Internal Memo

Subject
ALTO BULLETIN SYSTEM (AL01)

Date
May 22, 1978

FIGURE 1

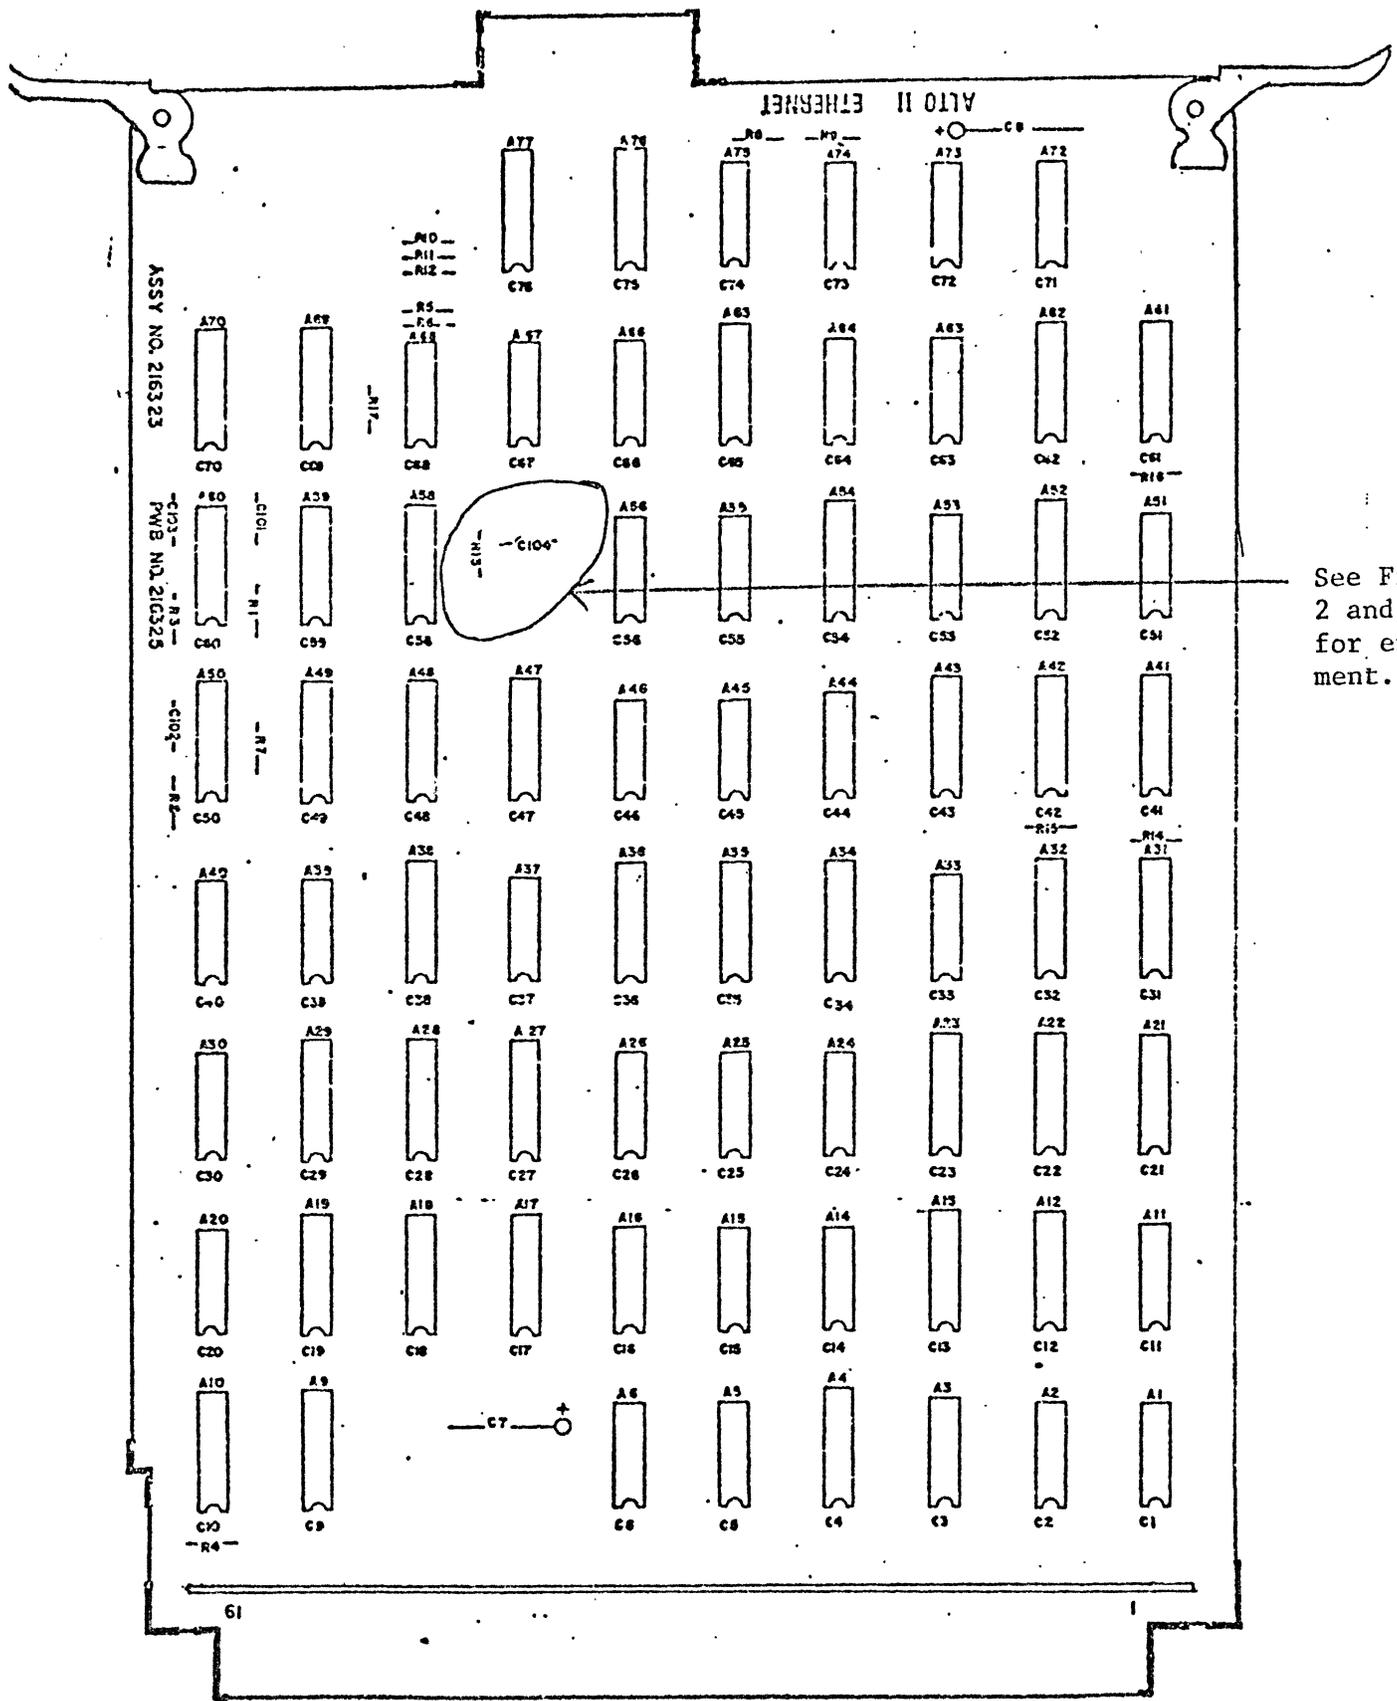
The Alto II Ethernet module, Assy. No. 216323, was found to have an Engineering Order (E/O) installed incorrectly. This only happened to approximately 16 Alto II's shipped around July 1978. However, all Alto II's that experience Ethernet type problems should be checked for this. The problems will show up as not booting from Ethernet (intermittent) or Transmission/Receive errors (using PUPTEST). Figure 1 shows where the E/O is located at on the module (attached).

See Figures 2 and/or 3 for enlargement.

FIGURE 2
Engineering Order Done Correctly

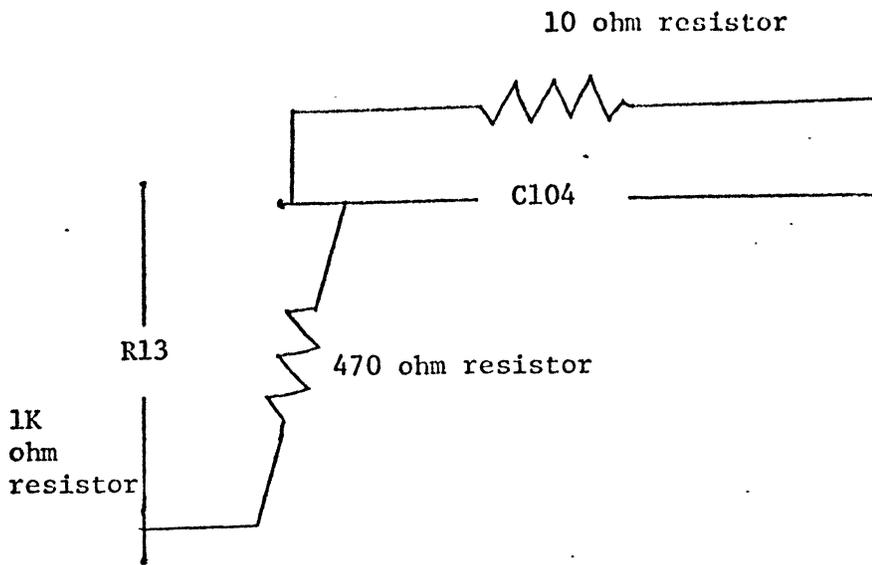
The E/O is shown correctly in Figure 2 and shown incorrectly in Figure 3 (attached). If you have any problems with Ethernet modules, please verify that the E/O as shown in Figure 2 is the same as the module. If the module matches Figure 3, rework the resistor to match Figure 2.

FIGURE 3
Engineering Order Done Incorrectly

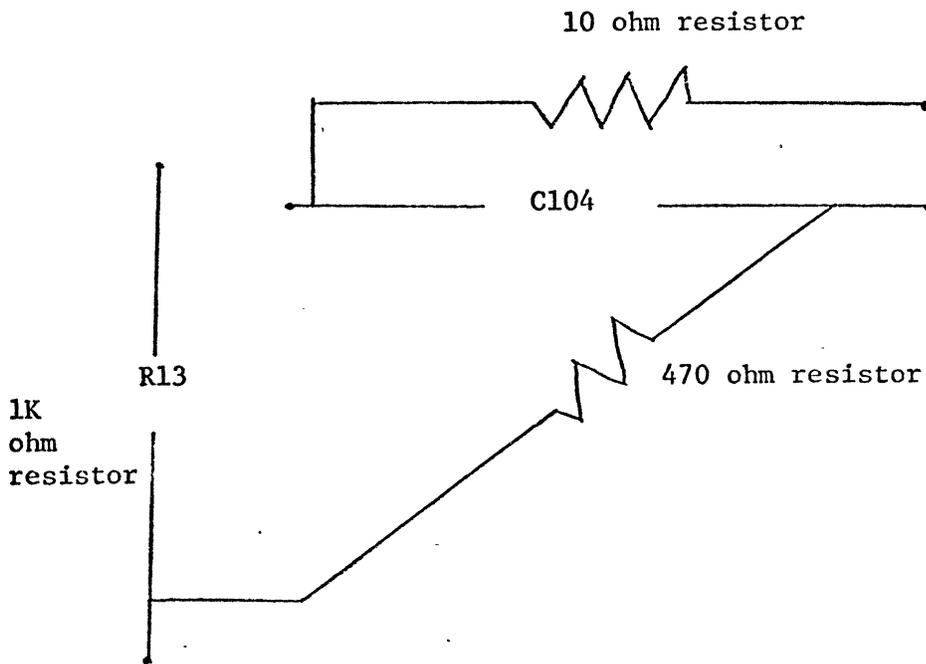
NOTE: The 470 ohm resistor is on the wrong end of capacitor C104. It should be on the same end as the 10 ohm resistor is.

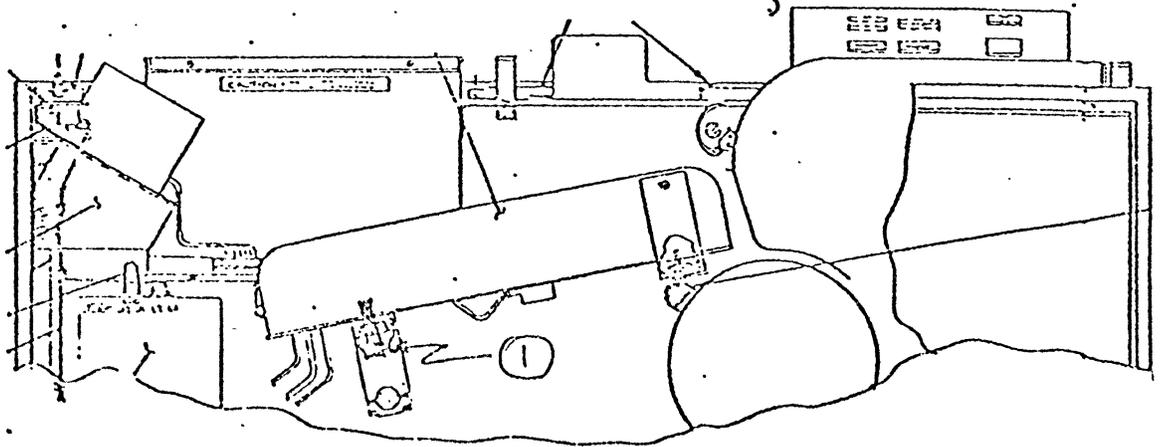
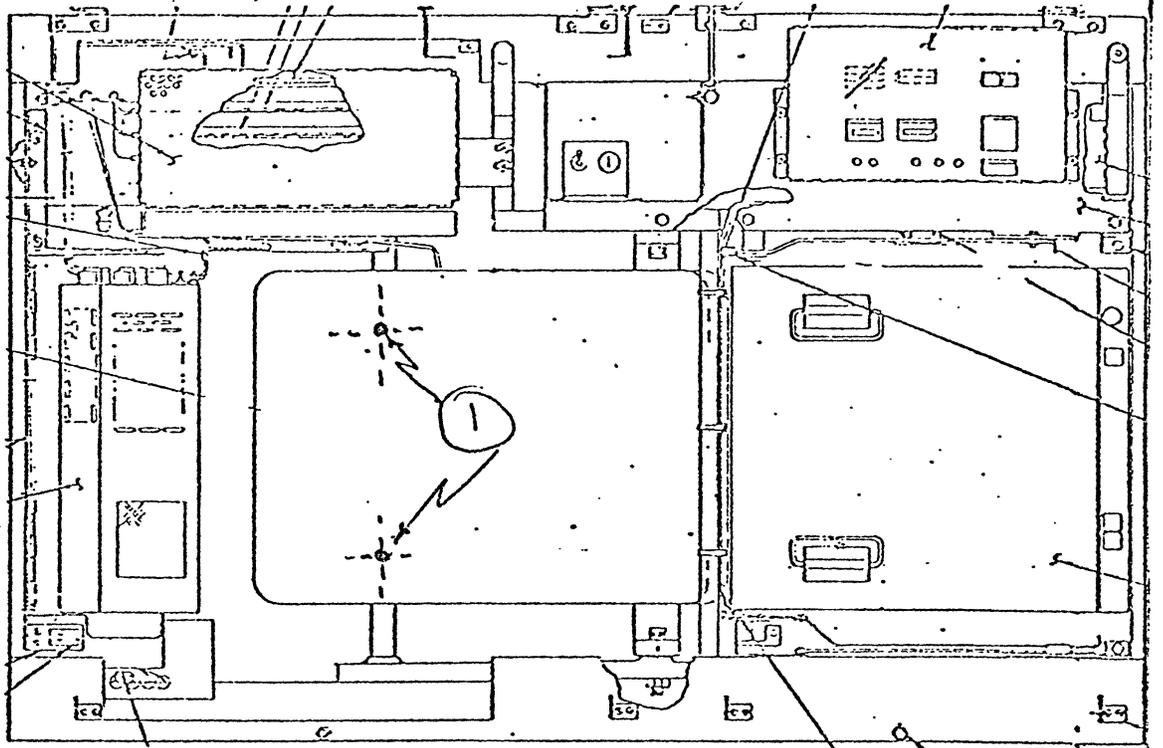
To prevent this problem, when a Dover is to be moved, the two allen bolts (item #1 on attached sheet) that attach the head to the lower mounting brace should be loosened before the Dover is moved. Then retighten the allen bolts once the Dover is in place.

REVISE SHEET 7

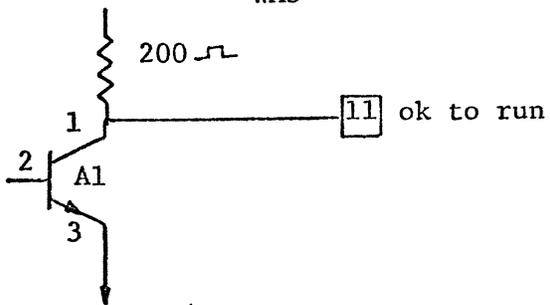
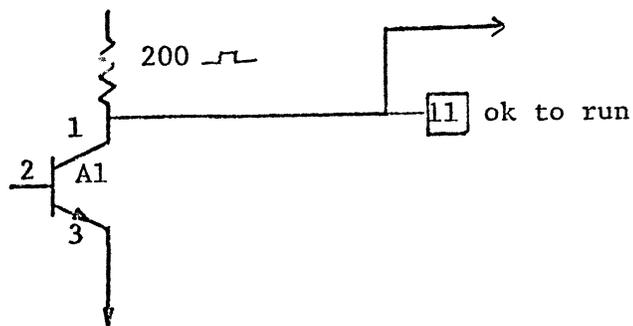
Any drawing relating to Disc Control Module, Assembly #216389, should be changed as shown in Figure 2.

SHEET 7

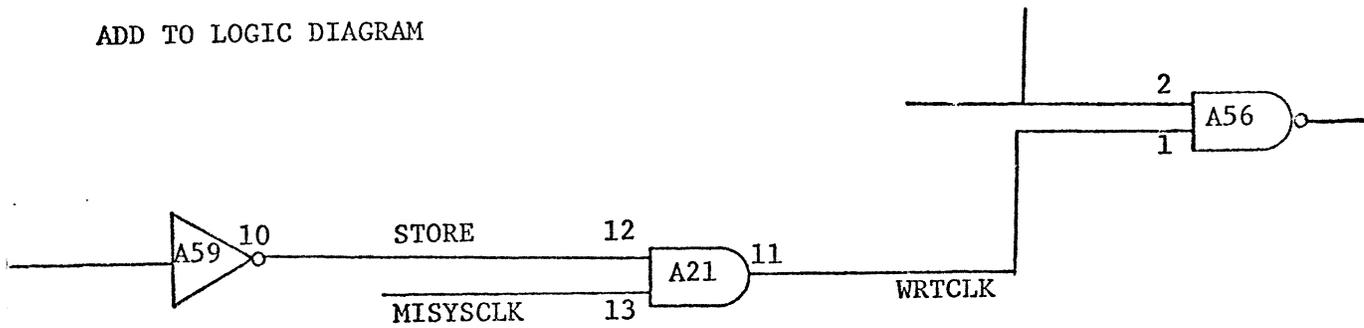
The drawing changes affected by this E/O are shown in Figure 2.

SHEET 12

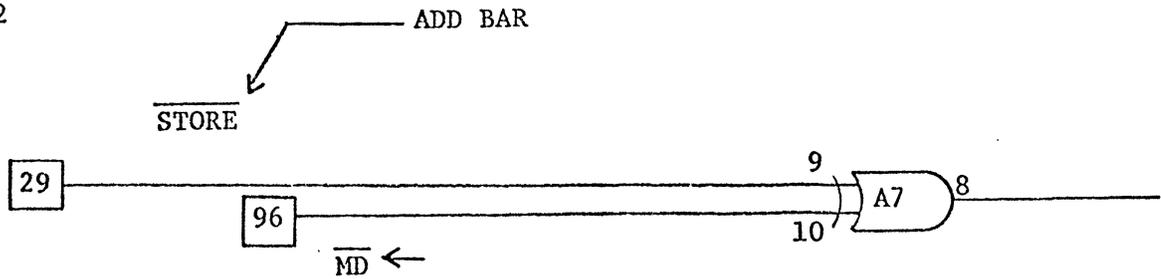
ADD TO LOGIC DIAGRAM

SHEET 12

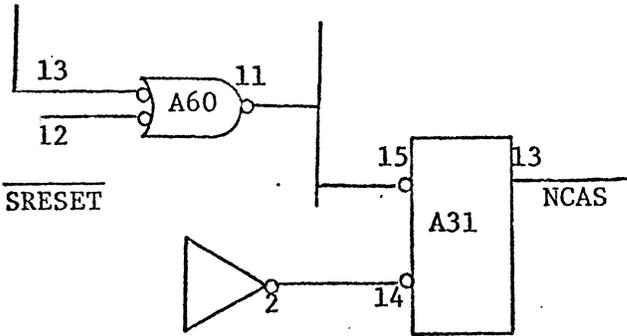
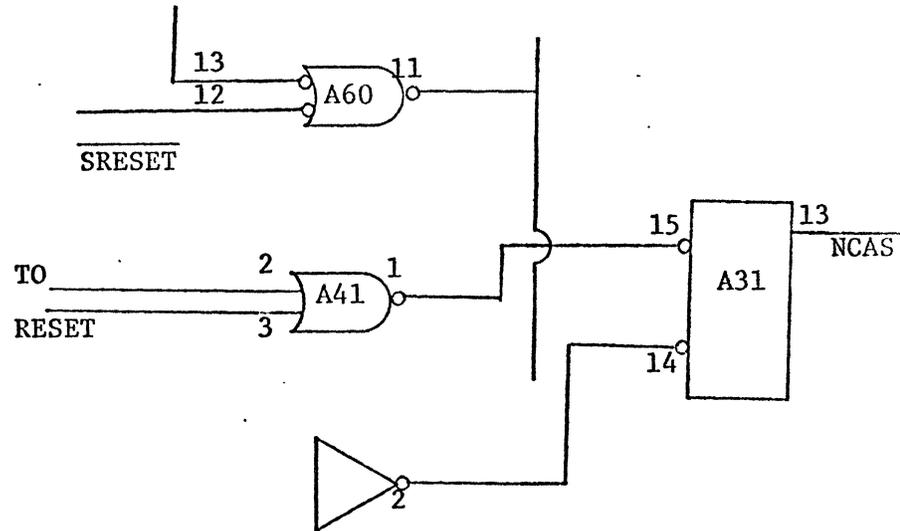
The drawing changes are the same for both assembly #'s and are shown in Figure 2.

FIGURE 1

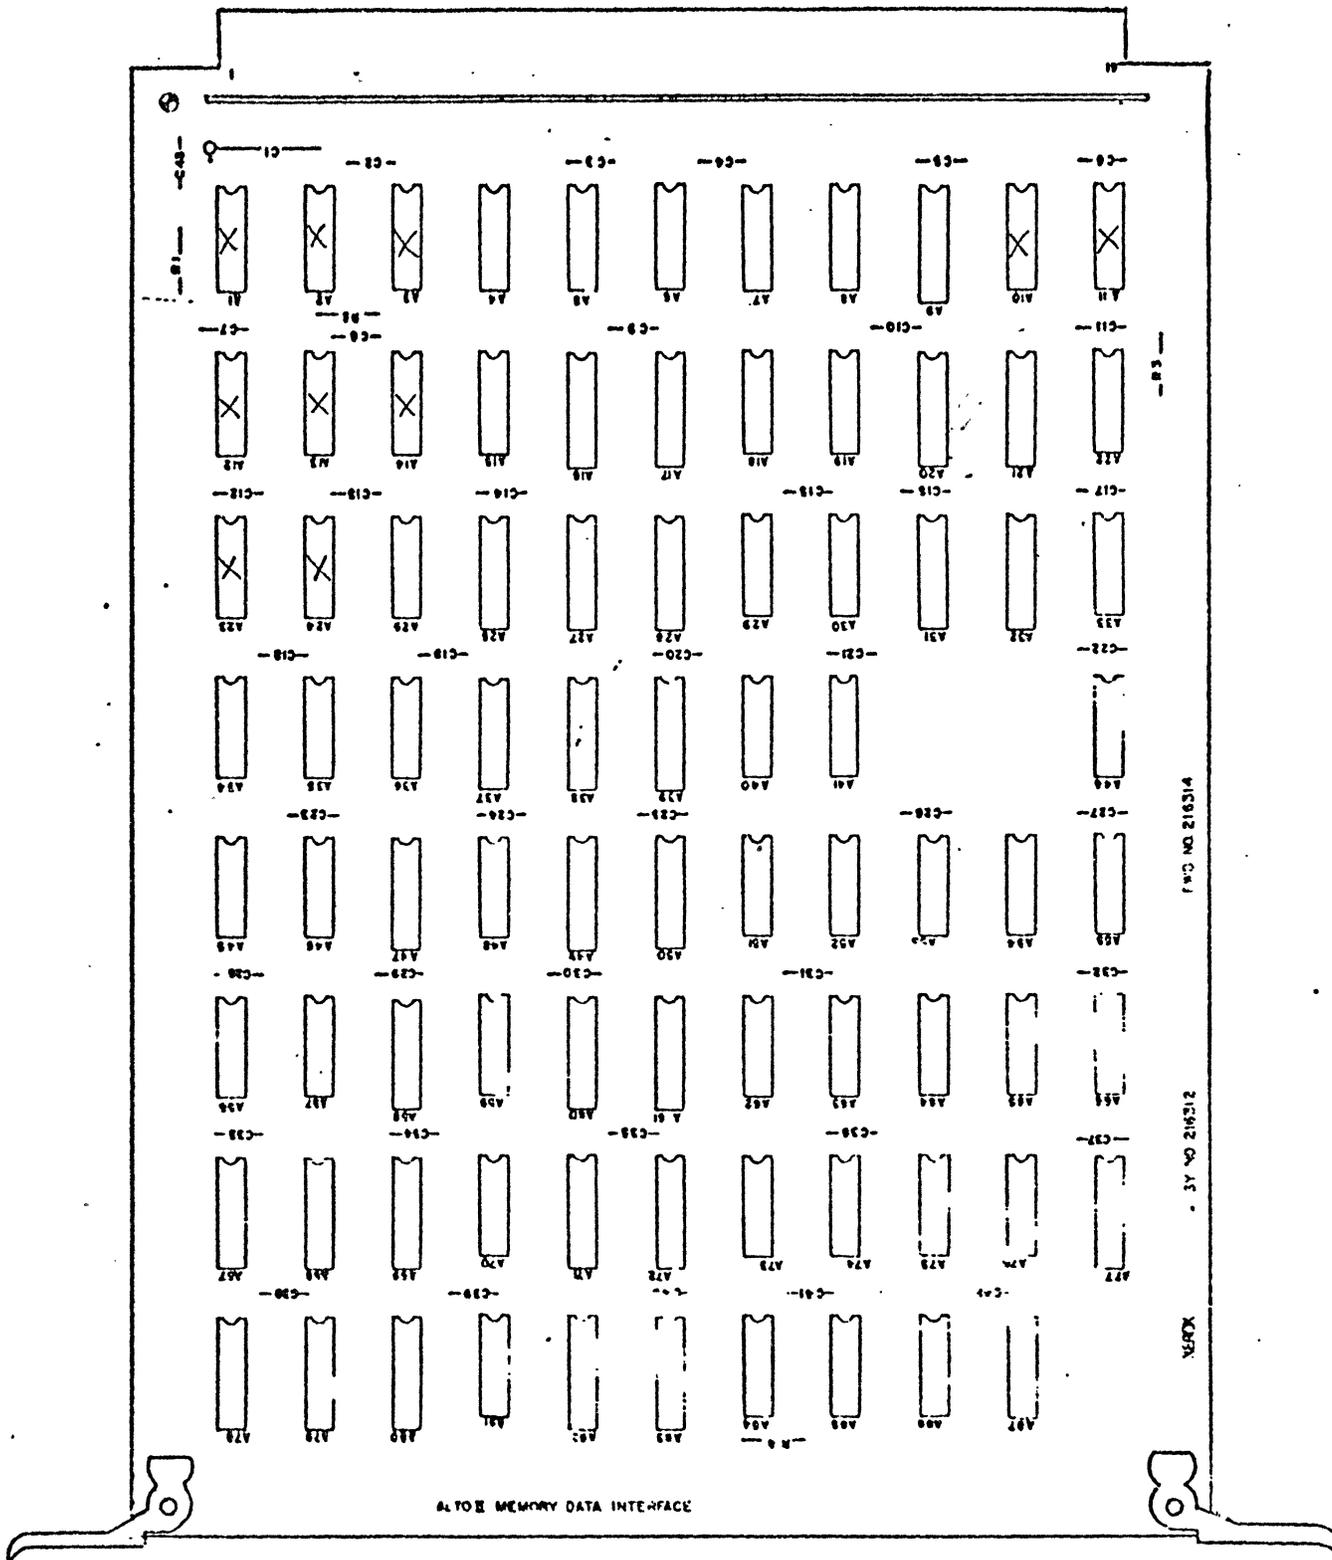
1. Remove the "74S132" microcircuits that are located in the following locations: A1, A2, A3, A10, A11, A12, A13, A14, A23, and A24. There should be a total of ten. See Figure 1.
2. Install new "74H00" microcircuits into the locations listed in step 1 making sure the microcircuits face the correct way in sockets.
3. Reinsert DIM Module into working Alto II and verify correct operation of all diagnostics.
4. After the E/O is completed, the DIM Module, Assembly #216312, should be Revision "D".
5. The chips removed in step 1 should be returned to me.
6. The chips required in step 2 are only being sent to the sites that have DIM Module, Assembly #216312, installed in non-extended memory Alto II's. These sites are: Boston, Rochester, and El Segundo.

Chip locations marked with (X) are ones referred to in step 1 of E/O.

connector side of board

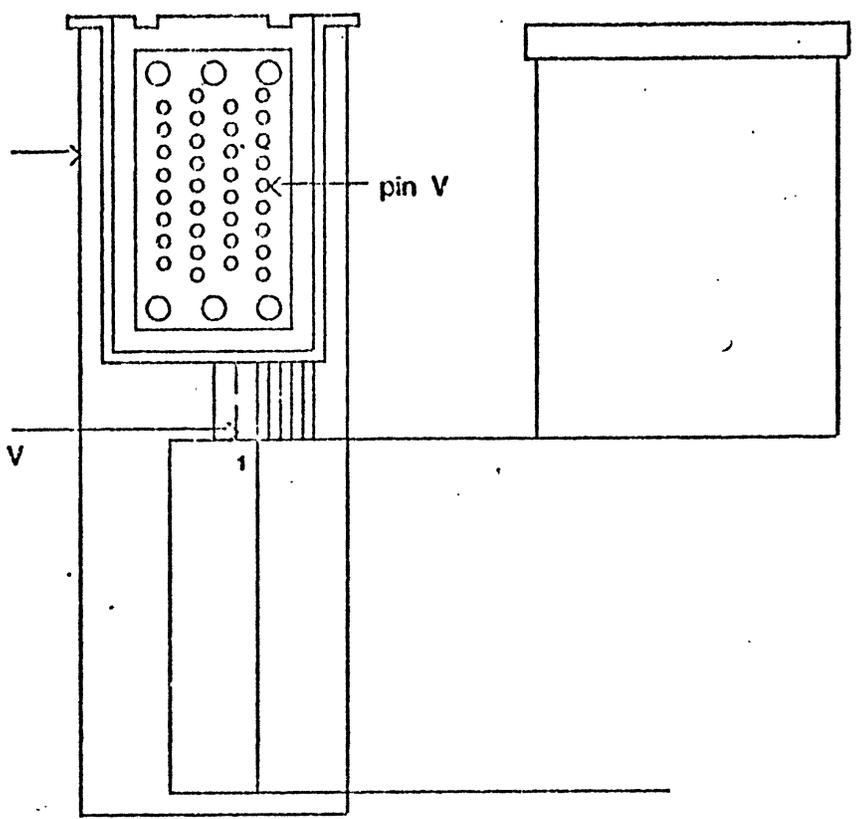
1. Remove power from Diablo Model 1355 WP printer.
2. Remove Diablo Hytype printer adapter cable (Diablo P/N 40508-03) from printer.
3. On connector (top) side of adapter cable board, cut etch between pin V of Winchester connector and pin 1 of ribbon cable connector. See attachment 1.
4. On etch side of board, solder a jumper wire between pin V of Winchester connector and pin 10 of ribbon connector. See attachment 1.
5. Reinstall printer adapter cable into Diablo Model 1355 WP printer.
6. Re-apply power to printer.
7. Verify proper operation by running all diagnostics and using hardcopy command on Bravo.

Cut etch as shown
Winchester conn. pin V
to ribbon cable pin 1

etch side of board

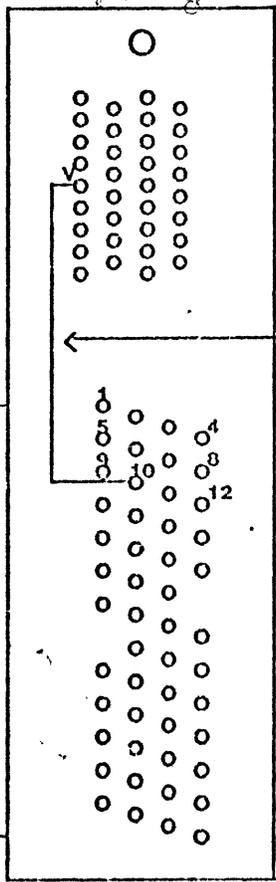
Add insulated wire between
Winchester conn. pin V
and ribbon cable pin 10
